LL.3/Circ.208
31 May 2012

**UNIFIED INTERPRETATIONS OF THE 1966 LOAD LINES CONVENTION AND
THE 1988 LOAD LINES PROTOCOL AS MODIFIED BY RESOLUTION MSC.143(77)**

3 The annexed interpretations revise the unified interpretations of regulation 25(2) and (3) of the 1966 LL Convention, as contained in LL.3/Circ.69.

Figure 1 – Guard rail stanchion of increased breadth, welded to deck with double continuous fillet weld with leg size of minimum 7 mm or as specified by the design standard

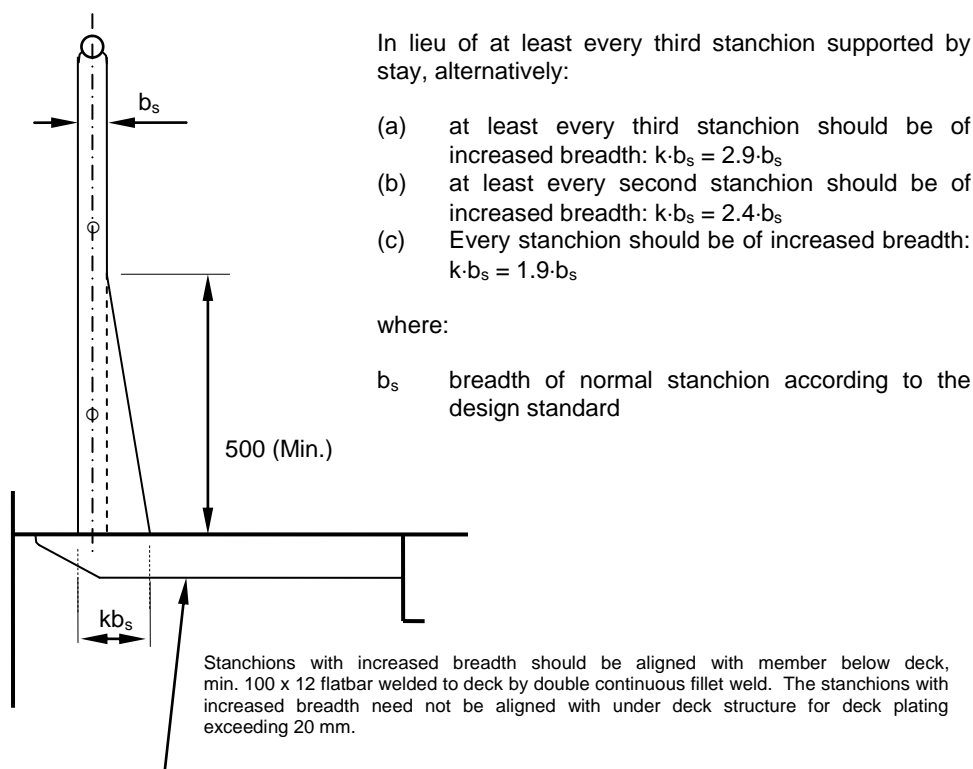
- 1 Fixed, removable or hinged stanchions should be fitted about 1.5 m apart.
- 2 At least every third stanchion should be supported by a bracket or stay. In lieu of this, flat steel stanchions should be of increased breadth as given in figure 1, and aligned with member below deck, unless the deck plating thickness exceeds 20 mm.
- 3 Wire ropes may only be accepted in lieu of guard rails in special circumstances, and then only in limited lengths.
- 4 Lengths of chain may only be accepted in lieu of guard rails if they are fitted between two fixed stanchions and/or bulwarks.
- 5 The openings between courses should be in accordance with regulation 25(3) of the Convention.
- 6 Wires should be made taut by means of turnbuckles.
- 7 Removable or hinged stanchions should be capable of being locked in upright position.

Figure 1 – Guard rail stanchion of increased breadth, welded to deck with double continuous fillet weld with leg size of minimum 7 mm or as specified by the design standard

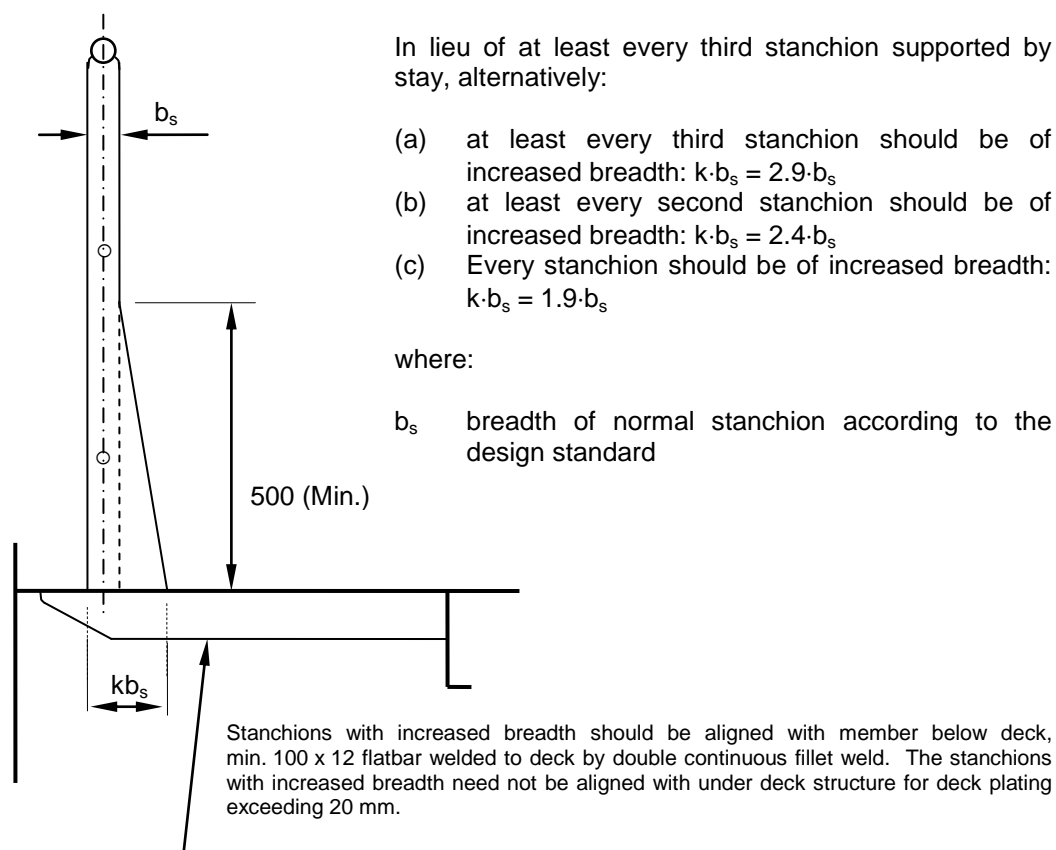
- 1 Fixed, removable or hinged stanchions should be fitted about 1.5 m apart.
- 2 At least every third stanchion should be supported by a bracket or stay. In lieu of this, flat steel stanchions should be of increased breadth as given in figure 1, and aligned with member below deck, unless the deck plating thickness exceeds 20 mm.
- 3 Wire ropes may only be accepted in lieu of guard rails in special circumstances, and then only in limited lengths.
- 4 Lengths of chain may only be accepted in lieu of guard rails if they are fitted between two fixed stanchions and/or bulwarks.
- 5 The openings between courses should be in accordance with regulation 25(3) of the Convention.
- 6 Wires should be made taut by means of turnbuckles.
- 7 Removable or hinged stanchions should be capable of being locked in upright position.

As alternate arrangements, flat steel stanchions should be of increased breadth, as given in figure 1, and aligned with members below deck unless the deck plating thickness exceeds 20 mm.
